PUD 66
Artesia II
at Forest Ridge

Artesia II at Forest Ridge
PT21-109 Sheet 1 of 2
Date of Preparation: October 23, 2024

21-047 Final Plat PH-2-Sheet 1 of 3_v1.pdf Markup Summary

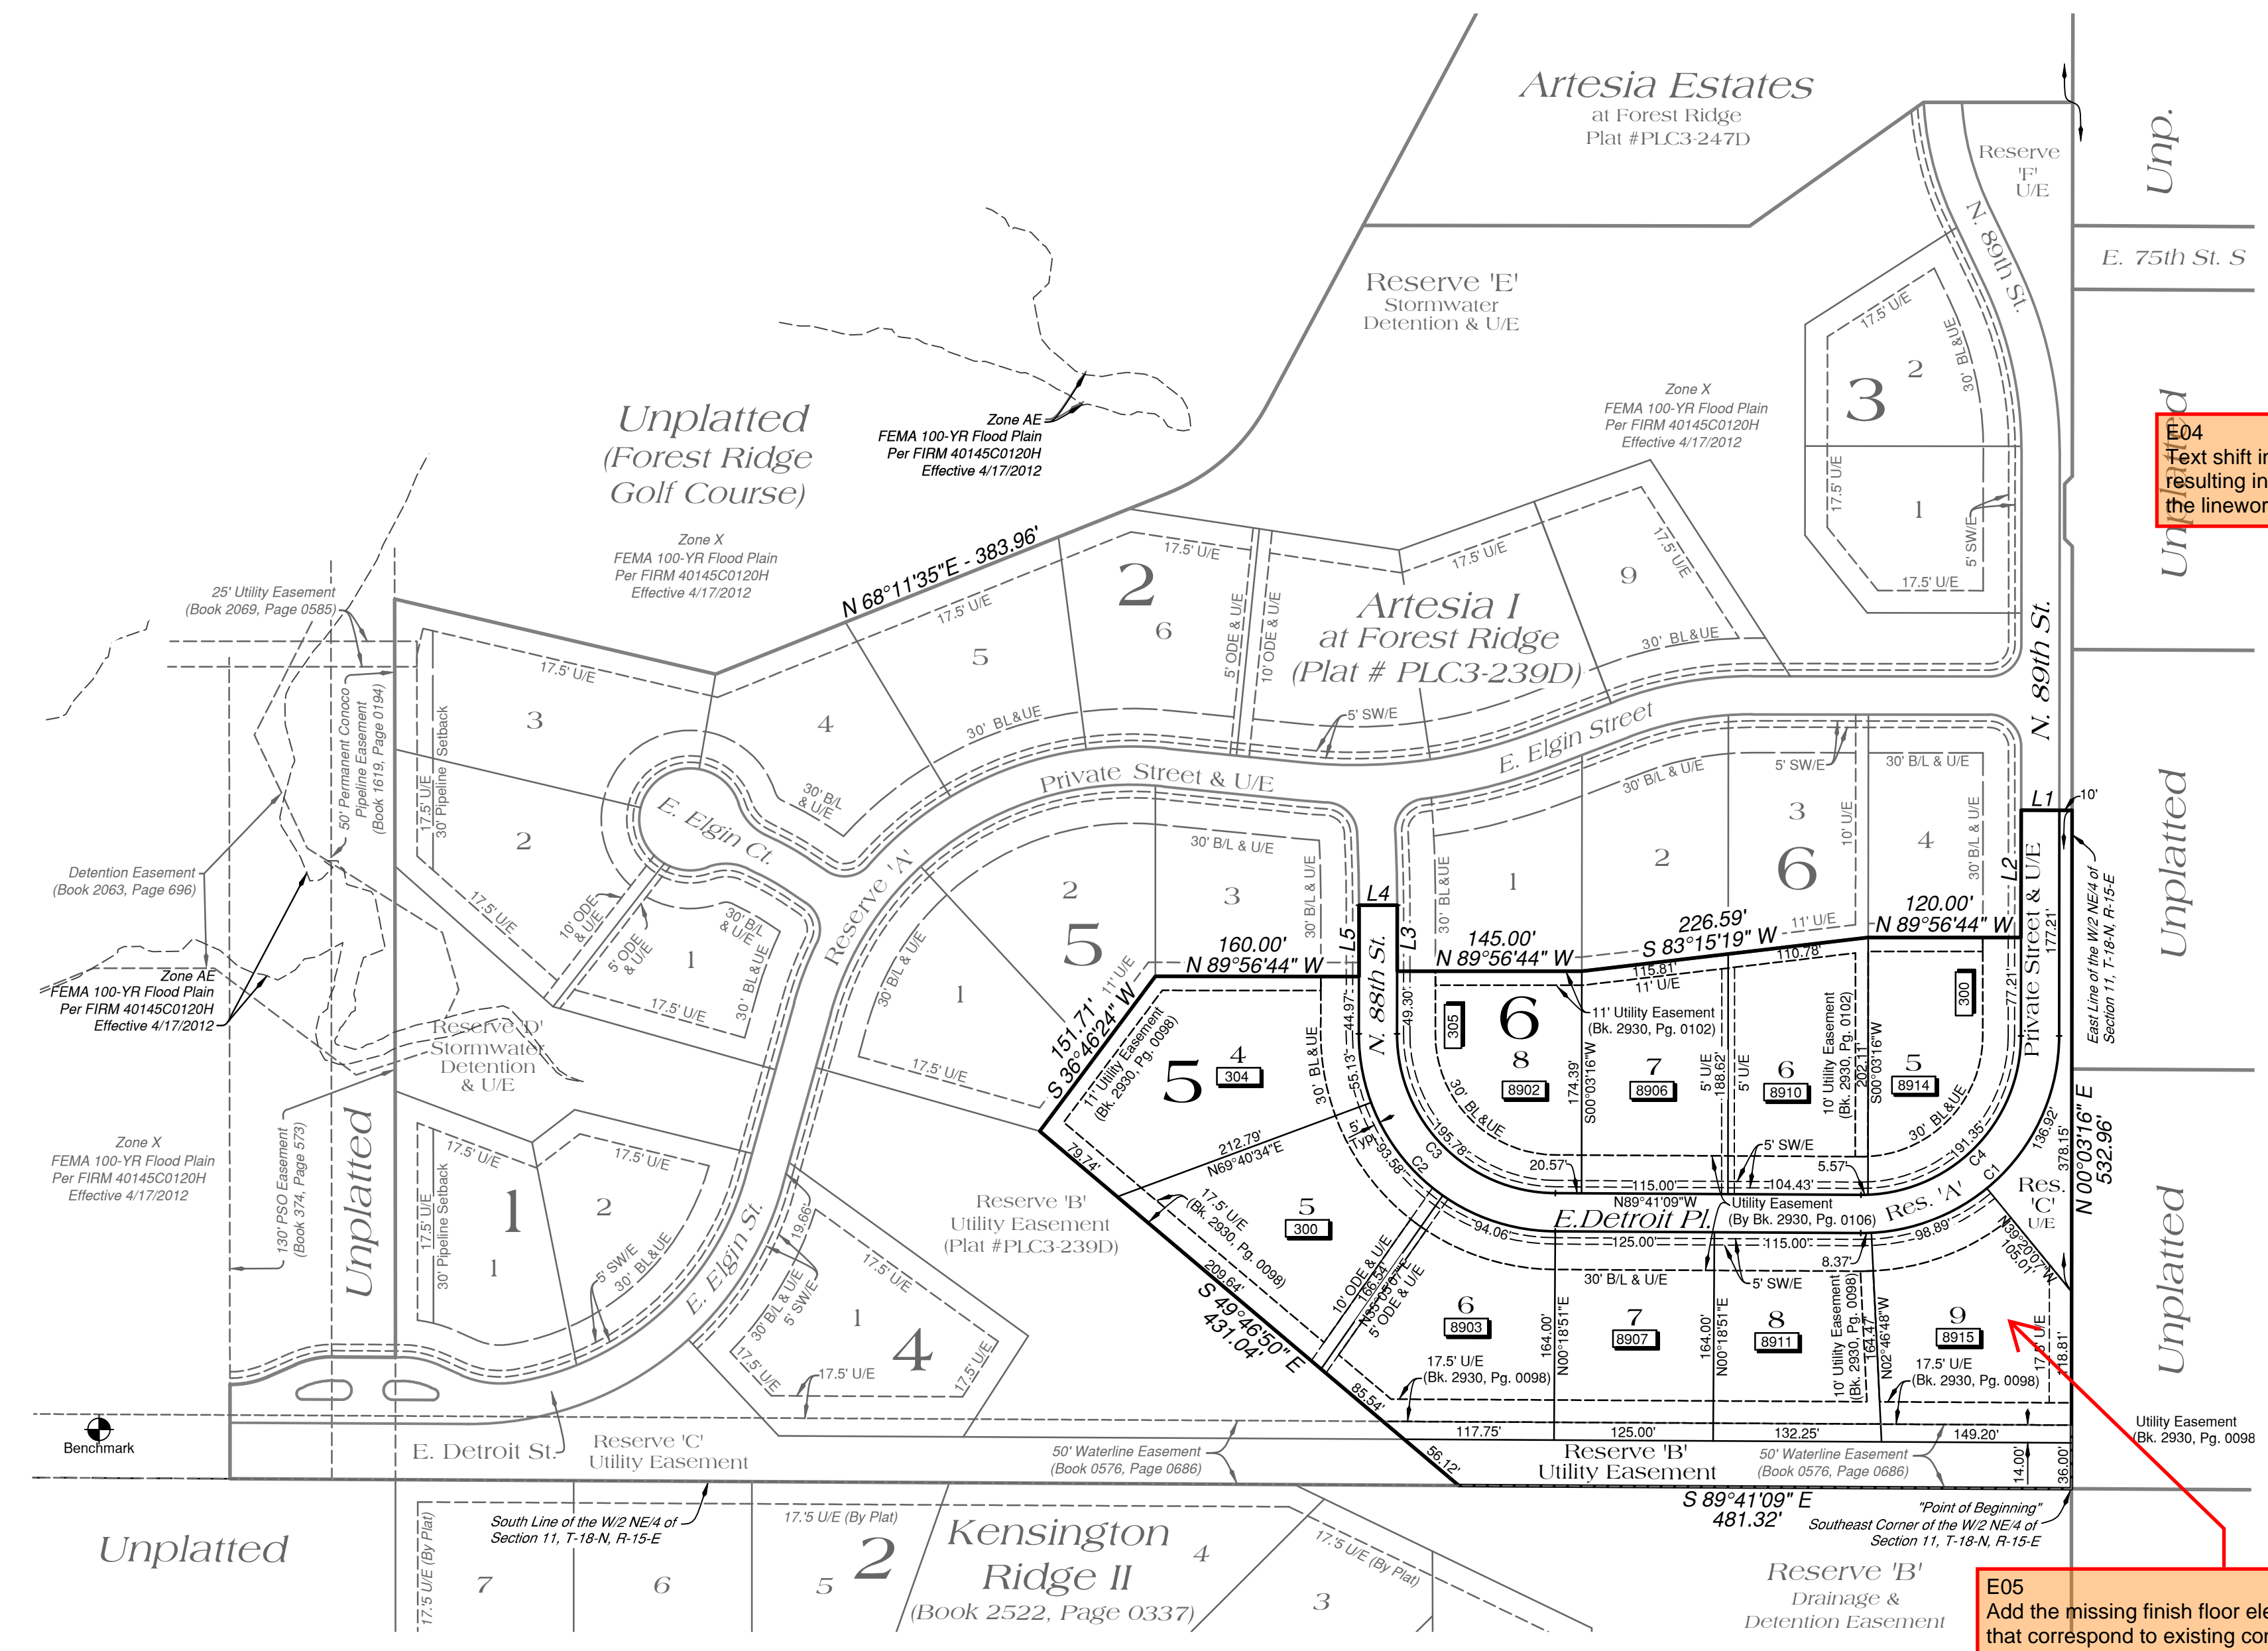
E01
The covenants were submitted using a PDF-A format that does not allow for
comments to be added to the pdf. In the submittal for the Final Plat Review
do not upload files to the application that are locked, protected, or use the
archive format.

E02
Covenants
Section 1.3 - Add a clarification note that all storm sewer in Artesia II is
private and the responsibility of the HOA to maintain.
Remove the storm sewer from section 1.3.4, the city will not maintain
private storm sewer facilities.
Section 1.7.2 - Include HVAC or pool equipment to the list as other
obstructions not allowed in the ODE
Section 1.8.6 - The subdivision is not set up to have private gates and the
gates are within the limits of Artesia 1 and Artesia Estates. This section is
set up to require artesia 2 to be responsible for the maintenance of the
gates instead of participating in the maintenance with Artesia 1 and Estates.

E07
Add the Acreage platted
and the square footage
from the legal description

E04
Text shift in the table for L1 and L4,
resulting in the text overlapping with
the linework

P02:
Update to reflect the
three pages
submitted.

E05
Add the missing finish floor elevations to each lot
that correspond to existing conditions per the
grading plans.
Verify that each lot has 4.5' of separation between the
finish floor elevation and the as-built elevations
of the sanitary sewer.

P01:
Update the project
number to
PR-000779-2024

E06
Verify that the As-builts for the water and sanitary
sewer have been submitted to Engineering and
Construction
